PŘÍKAZ K ZACHOVÁNÍ LETOVÉ ZPŮSOBILOSTI

Číslo: 2008-03-09

CFM International
CFM56-7B

Airworthiness Directives; CFM International, S.A. CFM56-7B Series Turbofan Engines

Figure 805

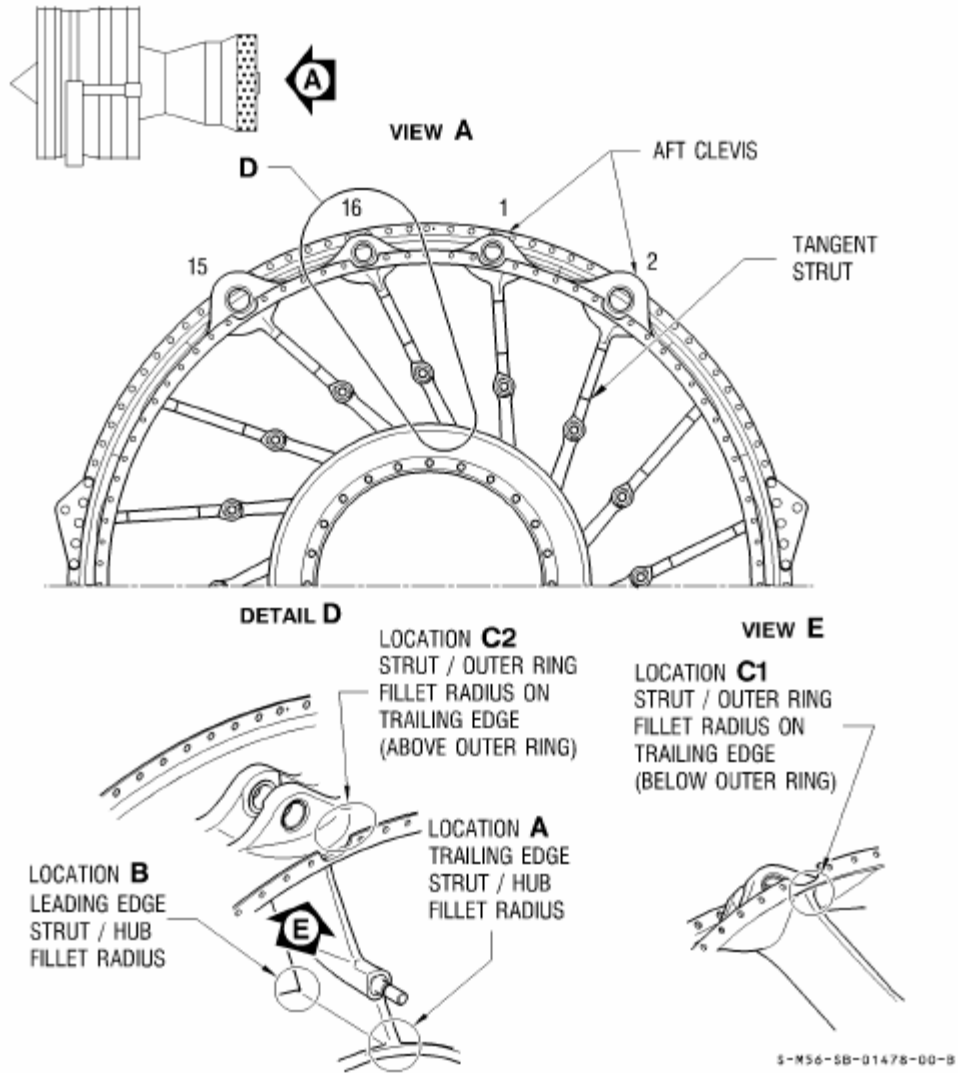
Update Table for Figure 805

Delta Airlines requests that we change the wording in the table for Figure 805 because CFM International updated CFM56-7B Engine Shop Manual section 05-21-03, with Temporary Revision 05-0080, dated December 5, 2006. We agree and have reworded the table for Figure 805 to reflect wording used by the original equipment manufacturer (OEM). For clarification, we also moved the titles for Figures 806 and 807 to the beginning of the figures.

2. Mandatory Inspection Intervals for the Critical Areas of the Turbine Rear Frame with Tangential Struts (4 Mount Struts, No. 1, 2, 15, and 16).
 - C. Turbine Rear Frame Part Numbers 340-166-205-0, 340-166-206-0, 340-166-207-0, 340-166-208-0, 340-166-209-0, 340-166-210-0, for all CFM56-7B SAC engine models (except -7B27A engine models). Refer to figure 805.

Figure Index No.	Inspection Location	Inspection Threshold (Cycles since new)	Inspection Intervals (Cycles)	Inspection Reference
805	Strut/outer ring fillet radius on trailing edge (A)	25,000* for -7B SAC (except business jet) engine models	Refer to Figure 806* for -7B SAC (except business jet) engine models	Refer to SB 72-0579*
	Strut/hub fillet radius on leading edge (B)	19,000* for -7B SAC business jet engine models	Refer to Figure 807* for -7B SAC business jet engine models	
	Strut/outer ring fillet radius on trailing edge (C1 below outer ring)			
	Strut/outer ring fillet radius on trailing edge (C2 above outer ring)

NOTE: * Applicable to all inspection locations.
If inspection is not performed, part must be removed.
